Origination Form

Proposed Revisions to a Standard Plans Index

Originator:	Caldwell, Carey Allie	Index Number:	700-101
Date:	6/30/2025	Sheet Number(s):	1
E-mail:	Carey.Caldwell@dot.state.fl.us	Index Title:	Typical sections for placement of single and multi-column signs

NEW SHEET 1

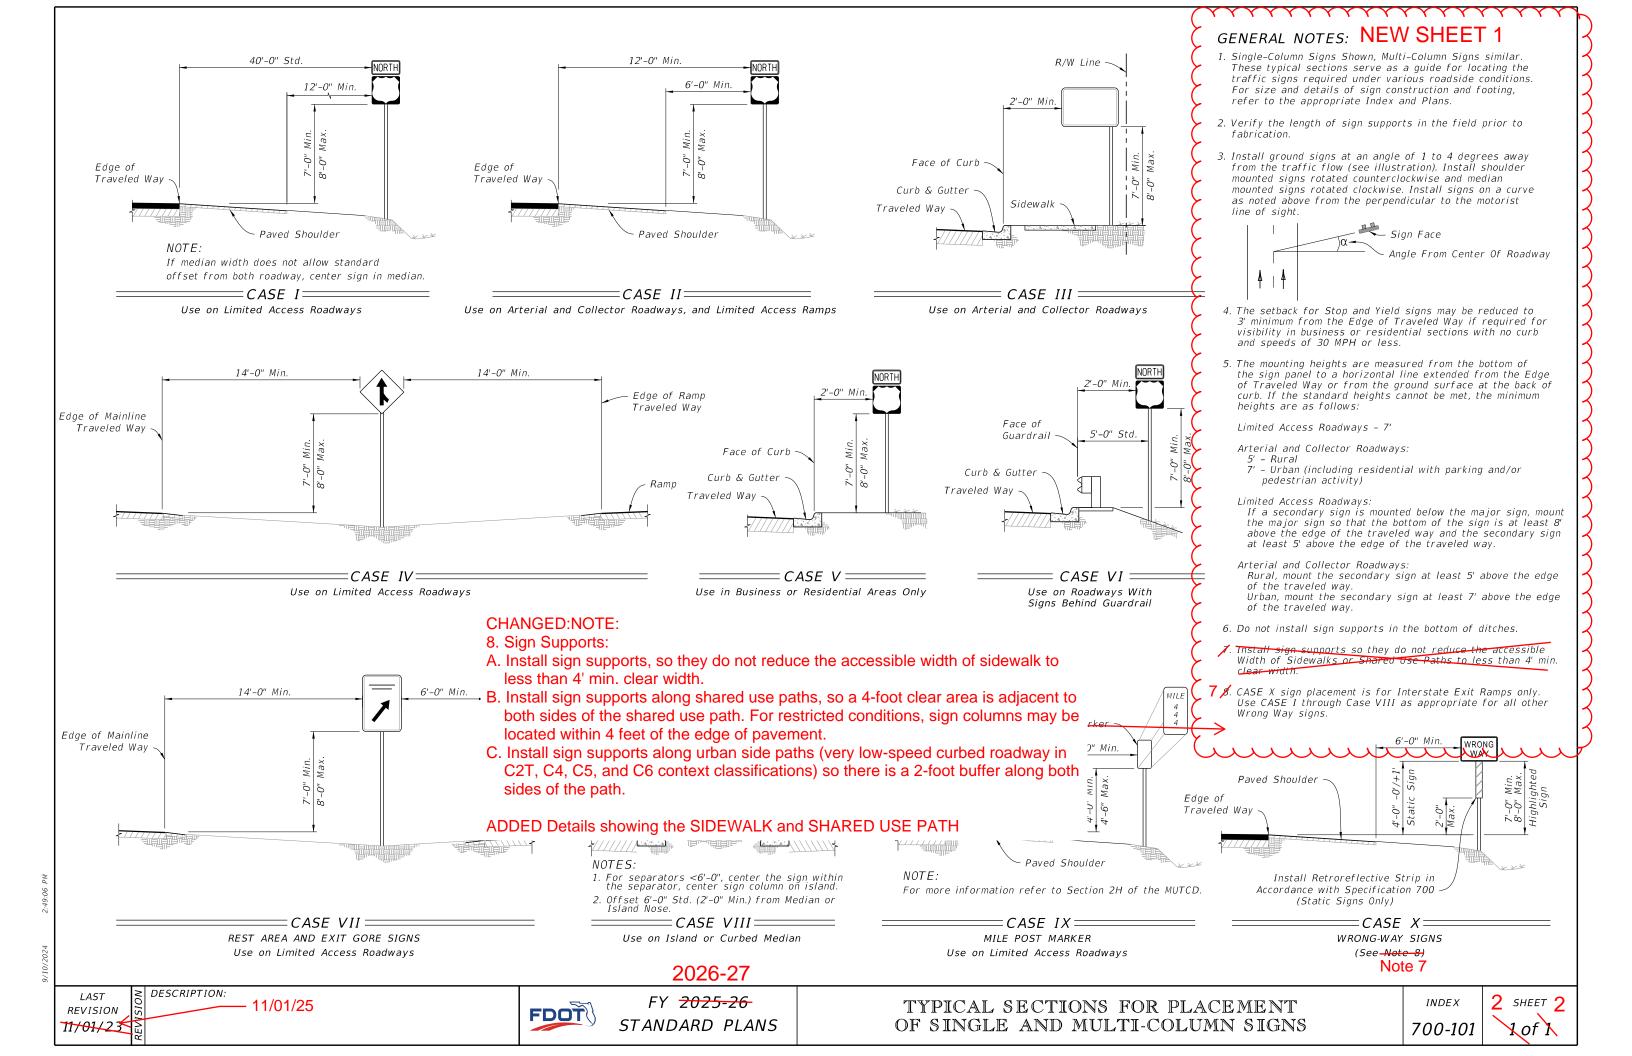
Sheet 1: Created General Notes Sheet; Deleted Note 7; Added New Note 8 "Sign Supports:

- a. Install sign supports so they do not reduce the accessible width of sidewalk to less than 4' min. clear width.
- b. Install sign supports along shared use paths, so a 4-foot clear area is adjacent to both sides of the shared use path.
- c. Install sign supports along urban side paths so there is a 2-foot buffer along both sides of the path." ADDED Details showing the SIDEWALK, SHARED USE PATH, and URBAN SIDE PATH

Note 7 does not provide enough information for placing signs along a shared use path or urban side path. Additional language is needed inform proper placement of sign columns along shared use and urban side paths.

- 6. Do not install sign supports in the bottom of ditches.
- 7. CASE X sign placement is for Interstate Exit Ramps only. Use CASE I through Case VIII as appropriate for all other Wrong Way signs.
- 8. Sign Supports:
- A. Install sign supports, so they do not reduce the accessible width of sidewalk to less than 4' min. clear width.
- B. Install sign supports along shared use paths, so a 4-foot clear area is adjacent to both sides of the shared use path.
- C. Install sign supports along urban side paths so there is a 2-foot buffer along both sides of the path.
